KPB File 2024-097

**ITEM #3 - PRELIMINARY PLAT
CROOKED CREEK RIDGE 2024 ADDITION**

KPB File No.	2024-097
Plat Committee Meeting:	September 23, 2024
Applicant / Owner:	Brett & Nancy Wendt And Stuart & Diane McElhinney all of Anchorage
Surveyor:	Mark Aimonetti
General Location:	Frosty Foot Ave in the Cohoe area

PRELIMINARY PLAT

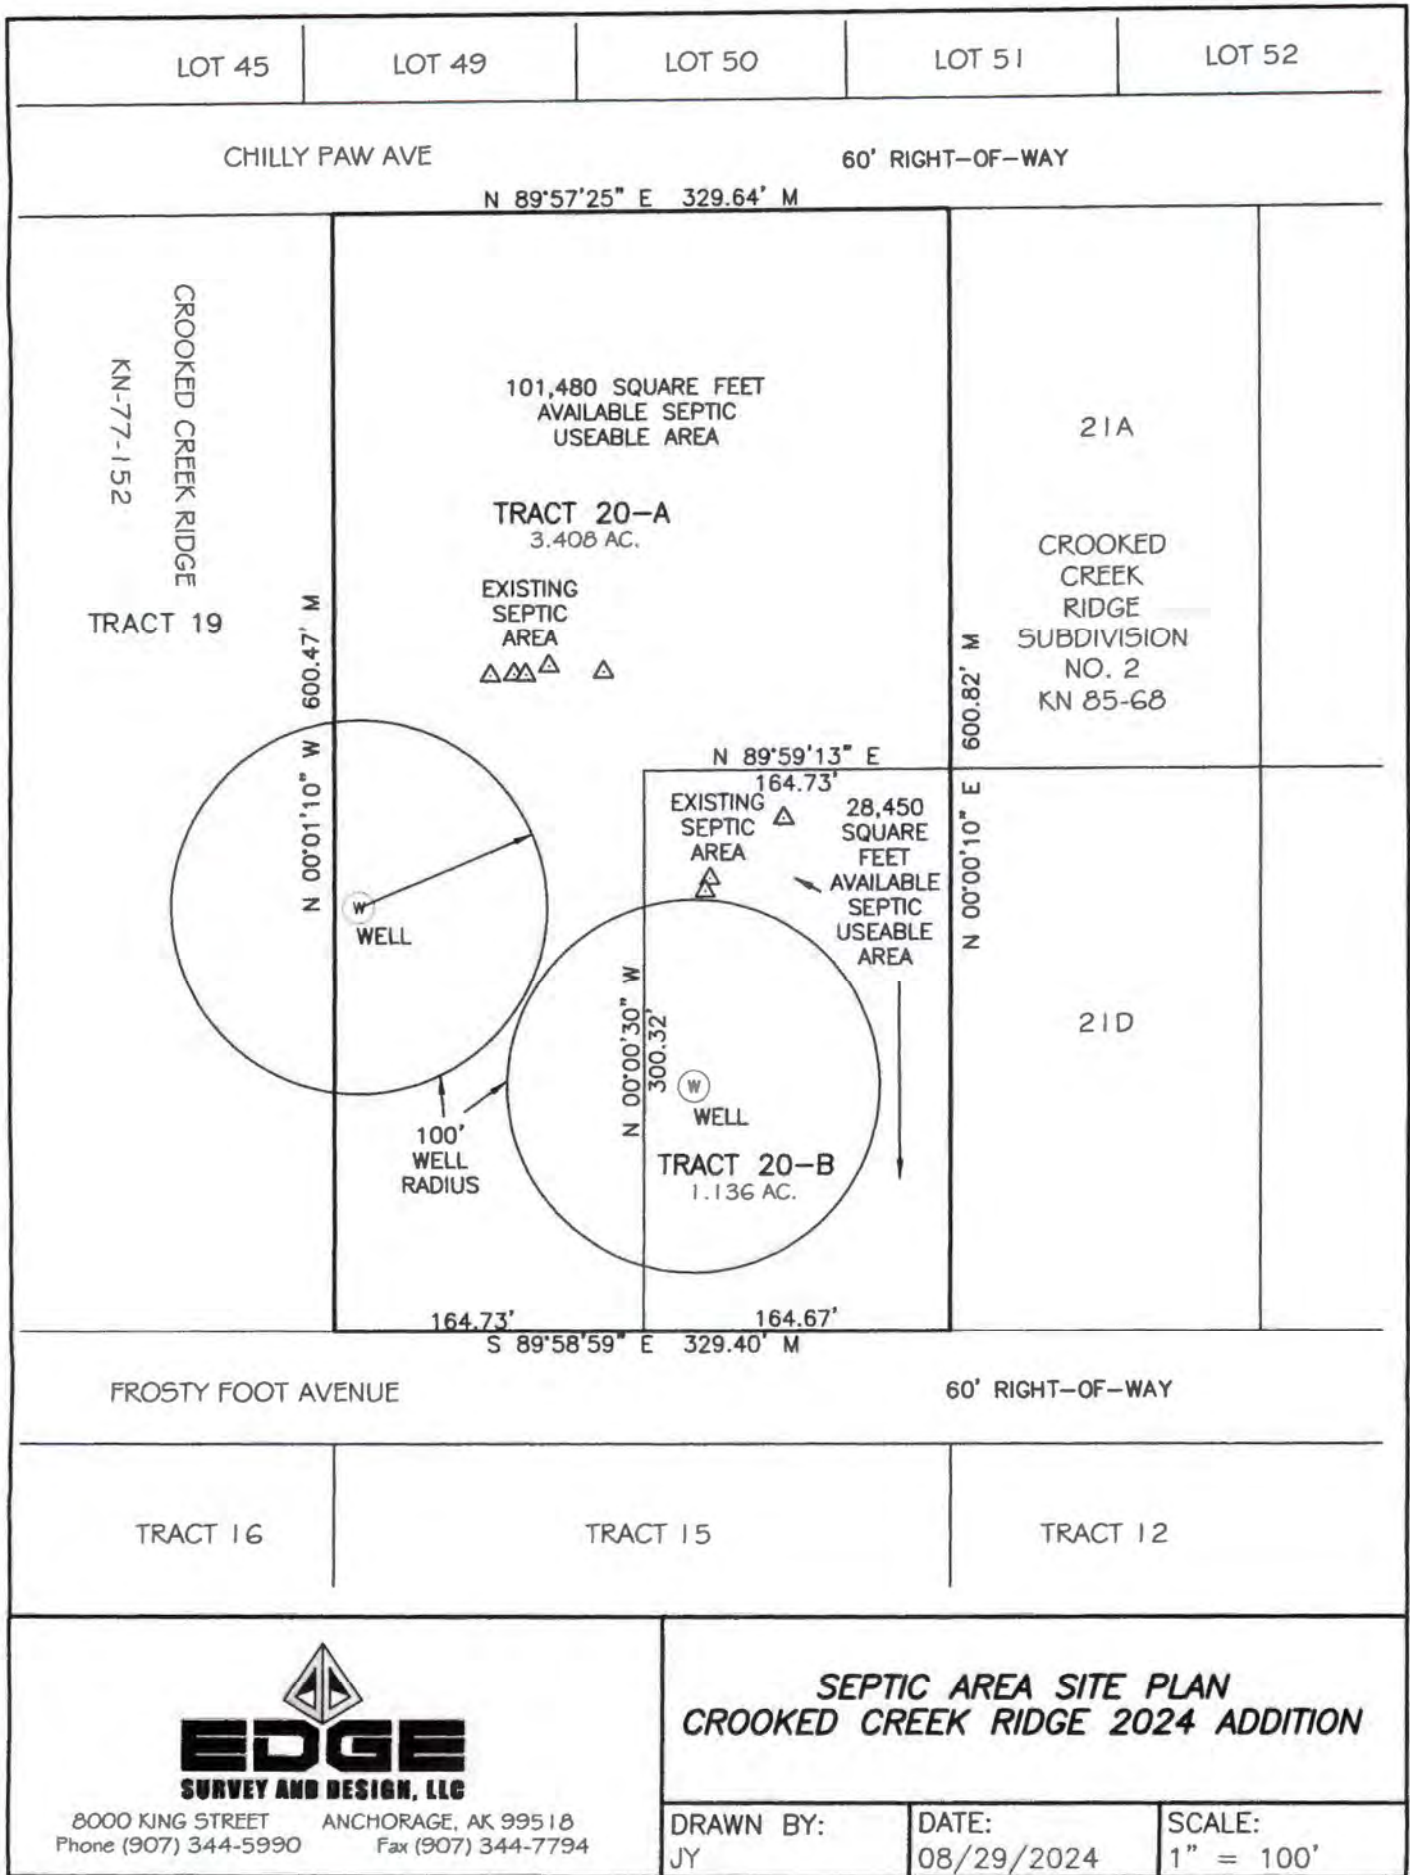
The certificate to plat notes a right-of-way easement to Homer Electric Association, Inc. in it that is labeled on the plat at note #3. The plat note needs corrected as there is two words ‘recorded’ in the note and ‘Homer Electric Association, Inc’ needs completely spelled out. **Staff recommends** plat note #3 be corrected as noted.

The plat drawing shows a 15’ utility easement on the drawing and identified at plat note #2, KPB 20.30.060(D) only requires the front 10’ adjoining rights-of-way to be designated as a utility easement. It is the surveyor’s decision to maintain the 15’ utility easement or reduce to a 10’ utility easement. **Staff recommends** the easement label on the drawing be changed from 15’ Utility Easement see plat note 1 to “see plat note 2”.

- Modify the KPB File to 2024-097 in the title block
- Plat note #3 needs corrected
- 15' Utility Easement note on drawing needs corrected

North Ridge Estates to the north of plat is three words.
The plat label to the north need changed to KN 86-133
